# Access Compliance Report

## Public Rights-of-Way

### (Curb Ramps)

Intersection ID: 27584	Main Street: ELM_LN	Cross Street: WILLIAMS_POND_LN	Location: SE
ADA ID: 48407EB7A6B5	Ramp Type: Perp	Initial Pass/Fail: Fail	Overall Compliance: No
Severity Score: 12.5			
Codes/Mitigation Info/Possible Solution		Field Measurements/Component Compliance

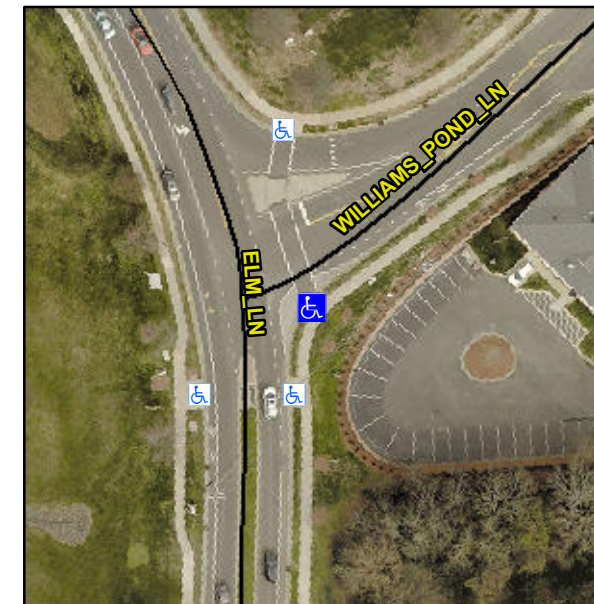
**Not Found, R304.2.2**

Compliance	Description	Data	Compliance	Description	Data
N/A	Ramp Length (in)	79.0	No	Ramp Slope (%)	8.5
Yes	Ramp Width (in)	48.0	Yes	Ramp XSlope (%)	0.2
N/A	Flare Type LT	N/A	N/A	Flare Type RT	N/A
N/A	Flare Slope LT (%)	N/A	N/A	Flare Slope RT (%)	N/A
N/A	Flare Traversable LT?	N/A	N/A	Flare Traversable RT?	N/A
N/A	Landing Length (in)	N/A	N/A	DWS Provided?	N/A
N/A	Landing Width (in)	N/A	N/A	DWS Contrast?	N/A
N/A	Landing Slope (%)	N/A	N/A	DWS Length (in)	N/A
N/A	Landing X Slope (%)	N/A	N/A	DWS Full Width?	N/A
N/A	Landing Curb? (Y/N)	N/A	N/A	DWS Offset (in)	N/A
N/A	Shared Landing?	N/A			
N/A	Gutter Ponding?	N/A	N/A	Gutter Slope (%)	N/A
N/A	Gutter Lip Ht (in)	N/A	N/A	Gutter X Slope (%)	N/A
N/A	Painted X Walk1?	Yes	N/A	Painted X Walk2?	N/A
	X Walk 1 Direction	To NE		X Walk 2 Direction	N/A
N/A	X Walk 1 Width (in)	112.0	N/A	X Walk 2 Width (in)	N/A
	X Walk 1 Slope (%)	1.3		X Walk 2 Slope (%)	N/A
	X Walk 1 X Slope (%)	0.7		X Walk 2 X Slope (%)	N/A

**Remove & Replace Entire Ramp.**
